Record of Executive Business and Chief Executive's Order

Reg. Reference: SD21B/0542 **Application Date:** 26-Oct-2021
Submission Type: Additional **Registration Date:** 27-Jan-2022
Information

Proposed Development: Removal of existing single storey extension and sheds to side and rear of house; construction of two storey extension to side of house and single storey extension to front of house; new vehicle entrance to front; new boundary treatments.

Location: 27, Ballyboden Road, Dublin 14

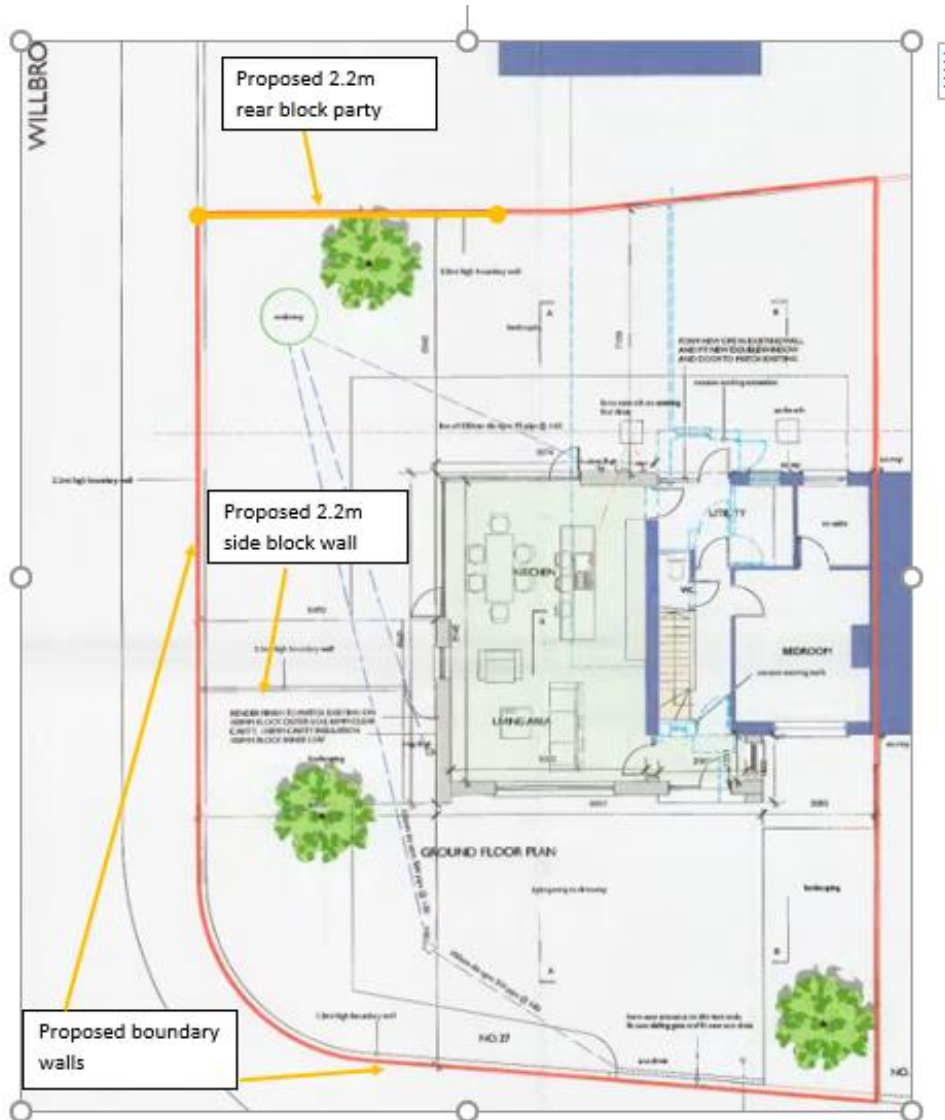
The applicant is requested to submit a revised layout of not less than 1:100 scale showing;

1.The proposed vehicular access point limited to a width of 3.5 meters.

2.The proposed 2.2m high rear block party wall limited to a max. height of 0.9m where it projects in front of property at 2 Willbrook Park in the interest of traffic safety and for visibility for vehicles egressing 2 Willbrook Park.

3.The proposed 2.2m high side block wall dividing the front and rear gardens limited to a max. height of 0.9m in the interest of traffic safety and for visibility for vehicles egressing 2 Willbrook Park.

4.All other proposed boundary treatment limited to a maximum height of 0.9m, and any boundary pillars limited to a maximum height of 1.2m, in the interest of traffic safety and to improve forward visibility for vehicles.
